Request from O. Glen Kemp (owner) to rezone property located at 3749 & 3801 East University Avenue.		File #		
		ZON2008-00036		
Description of Action	Rezone property from "C-1" Neighborhood Retail Commercial District and "R1-60" One-Family Low-Density Residential District to "C-2" General Retail and Highway Oriented Commercial District, to allow for redevelopment of the property for miniwarehouse use.			
2020 Community Character Plan	Low-Density Residential & Commercial: Auto-Oriented Small-Scale Strip Development			
Horizon 2025 Transportation Plan	E University Avenue from E 33 rd street to East City Limits to widen from 4 lane undivided to 5 lane undivided			
Current Zoning District	"C-1" Neighborhood Retail Commercial District and "R1-60" One-Family Low-Density Residential District			
Proposed Zoning District	"C-2" General Retail and Highway Oriented Commercial District			
Consent Card Responses	In Favor	Not In Favor	Undetermined	% Opposition

ZON2008-00036

Honorable Mayor and City Council
City of Des Moines, Iowa

Communication from the City Plan and Zoning Commission advising that at their meeting held April 17, 2008, the following action was taken:

SITE PLAN FOR A TO Z
 3749 E. University Ave
 Des Moines, Iowa

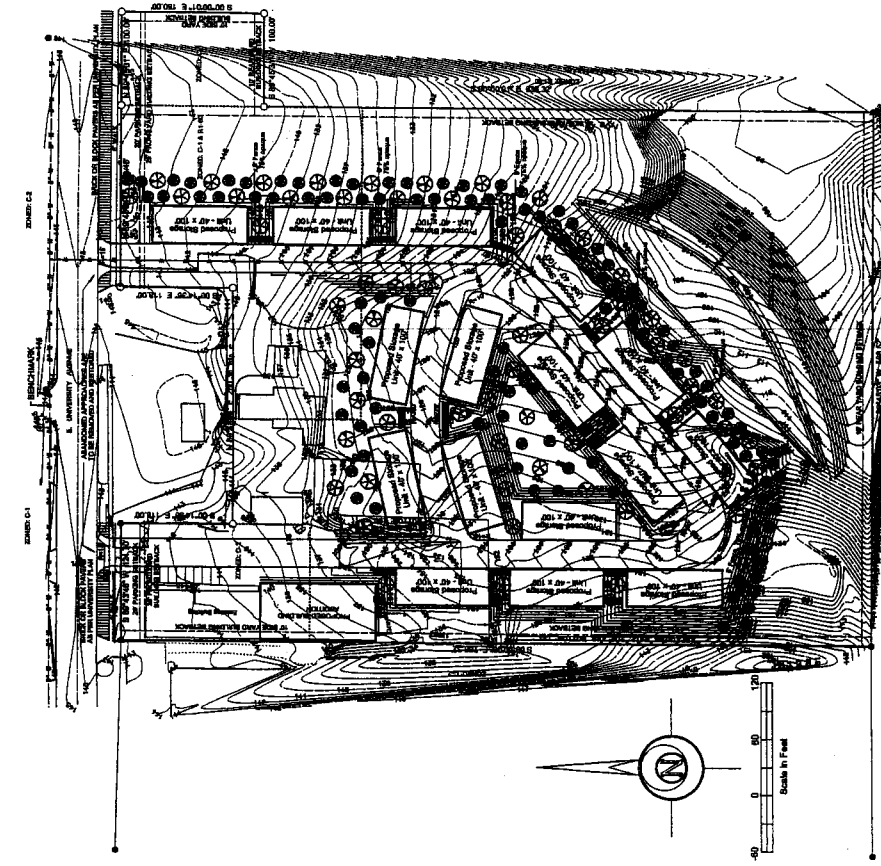
1. Natural Site Features: The south half of the site is a natural open space area with dense trees along the south and east property lines. The site gradually slopes downward to the east. The submitted site schematic anticipates that trees along the south and east boundaries of the property will not be disturbed based on the ability to develop utilizing existing grades. A tree survey identifying trees six-inches and larger will be required with the submittal of any site plan for development.

Any future development will be required to meet all grading/soil erosion protection and storm water management policies during Site Plan review. The site schematic indicates the intent to provide storm water detention at the southeastern portion of the development, with a piped release into a dissipater to prevent any erosion from the controlled rate of release. The development is also subject to recently adopted post construction run-off- requirements which may necessitate a design using conservation methods to absorb part of the run-off into the ground on-site.

3. Landscaping & Buffering: Any future development will be required to meet the landscape standards of the Site Plan policies. The submitted site schematic indicates the intent to comply with minimum bufferyard and open space plantings. The schematic shows that the fencing will be placed and the bufferyard plantings will be planted tighter to the miniwarehouse buildings rather than spread at the perimeter of the property where it abuts residential uses. Staff believes that this will be more effective in screening the use based on the existing grades.

5. **Access or Parking:** The subject property is accessed by two driveways from East University Avenue. The former A to Z Rental business area is accessed by one driveway and the single-family residence is accessed by an additional driveway located just east of the adjoining Git-n-Go. The submitted site schematic contemplates a 30' wide looped drive aisle allowing for Fire apparatus access or two-way traffic and parallel parking.

Tim Urban: Expressed concern that the property is heavily wooded on the south and southeast, yet they will have to grade the southeast because of storm detention. Suggested 8 buildings could be pushed north in a tighter configuration to leave the entire southeast portion of the property from interference and place the storm detention in the middle of the property.

Mike Ludwig: Noted they have to come through the site planning process and they would be asked to identify trees on the property at that time. There could be adjustments to the buildings to limit the impact on significant trees, but that would be dealt with in the site plan review.
